## PHASE 2 - WESLEY BRADLEY PARK

EXISTING SITE AND TESC PLAN NORTH  
FOR  
CIVIL PLANS  
PHASE 2 - WESLEY BRADLEY PARK

Job Number  
16718  
Sheet  
C2 of 19

BY: \_\_\_\_\_  
DATE: \_\_\_\_\_

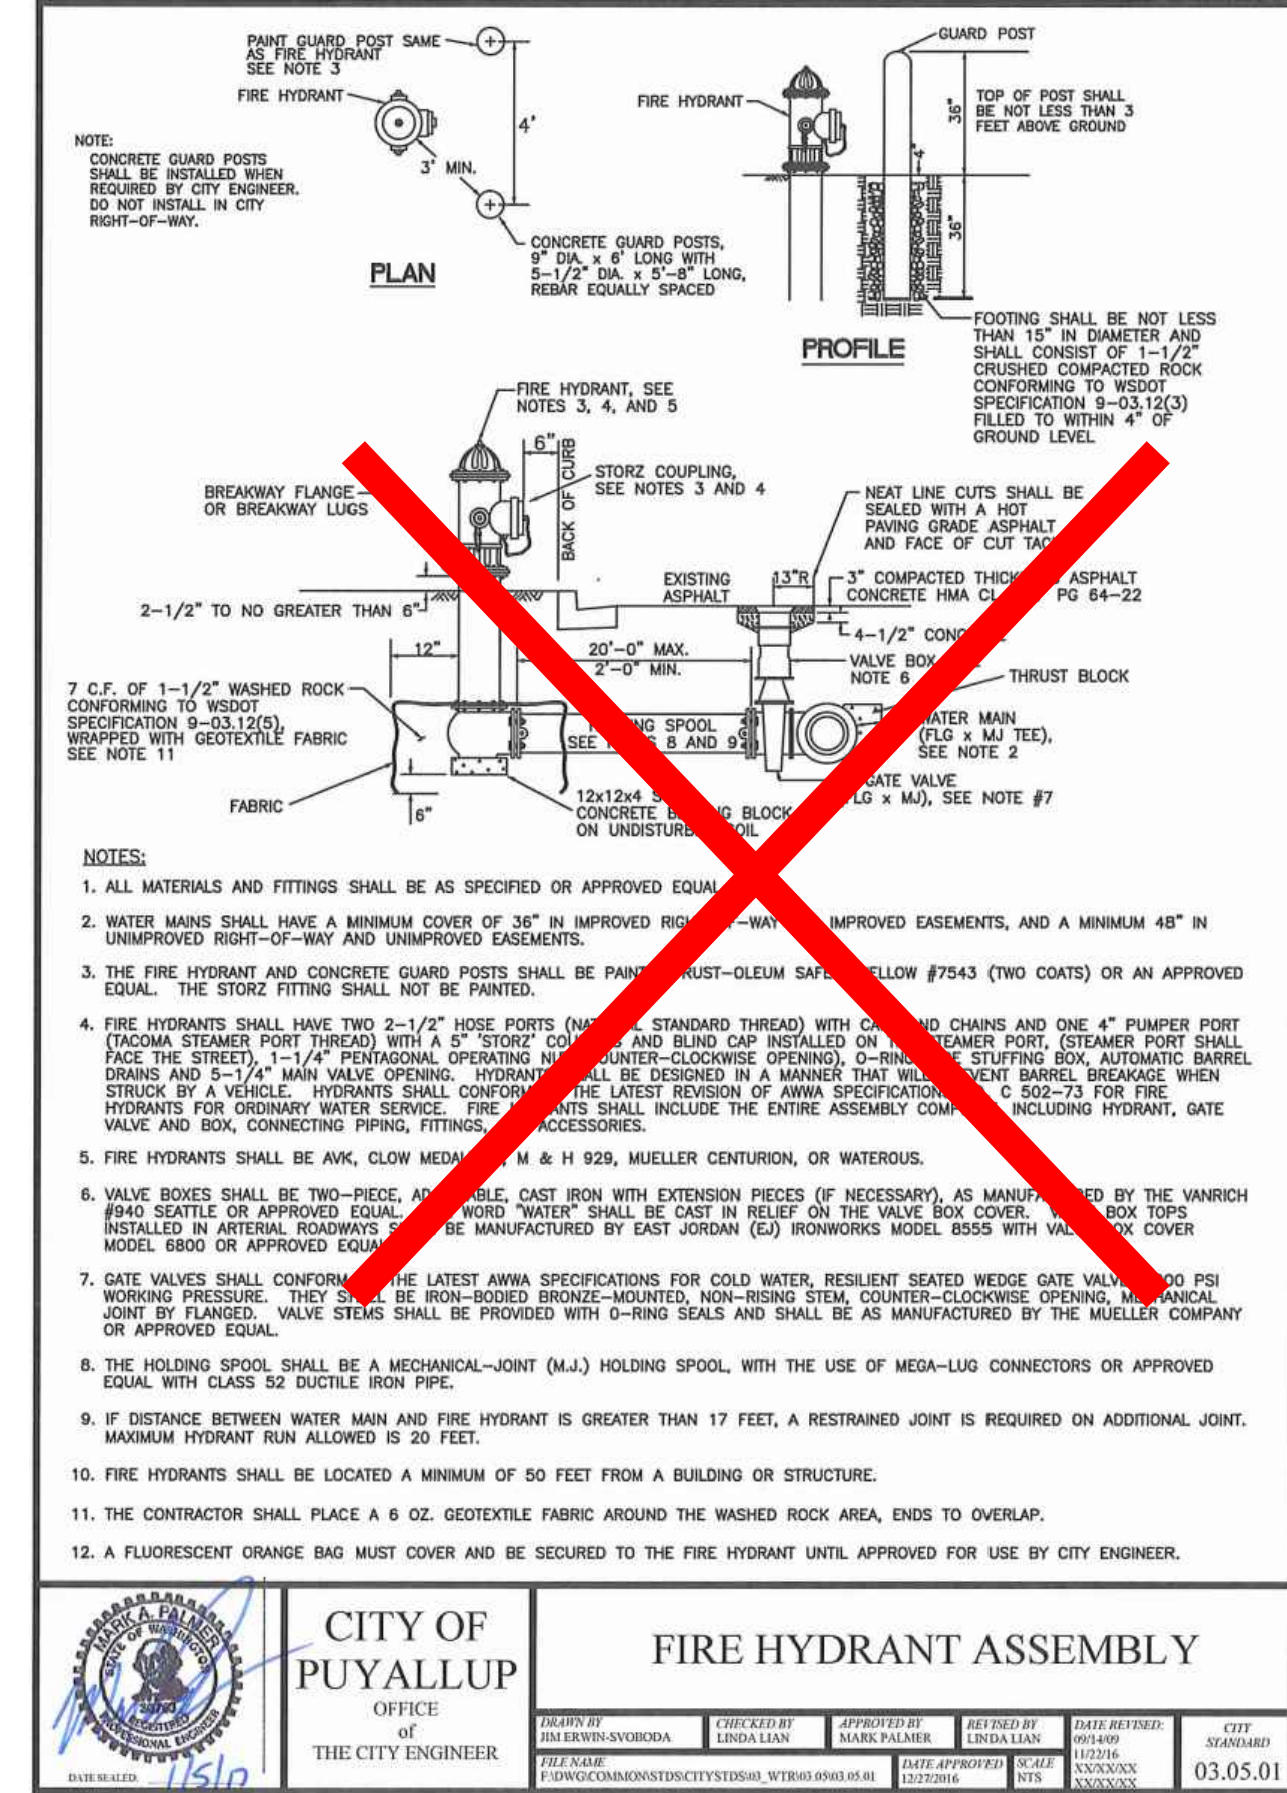
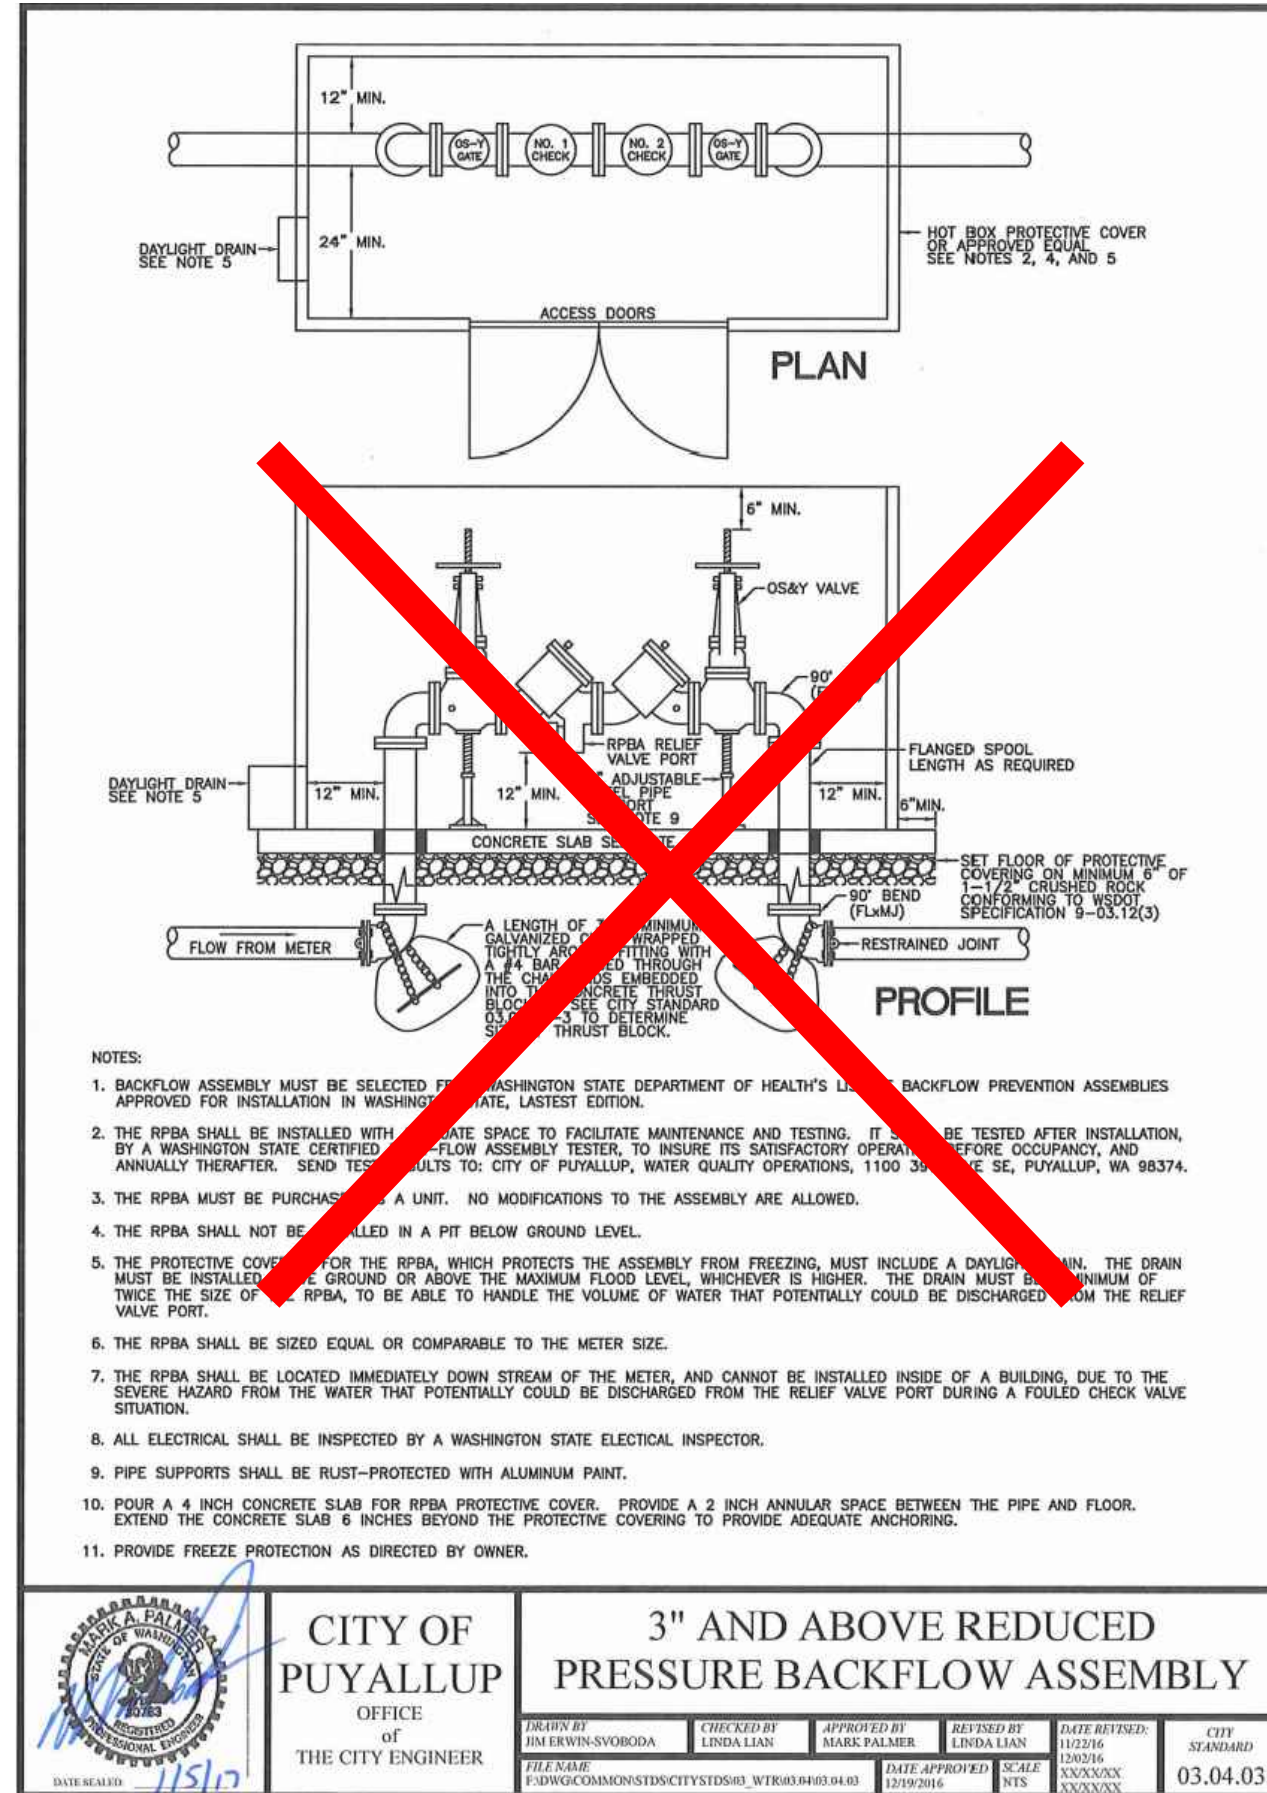
Update all of these details to current standard.  
[Plans: Sht C17 of 19]

Civil Sheet C17: Remove this standard detail. It is not needed for this project.
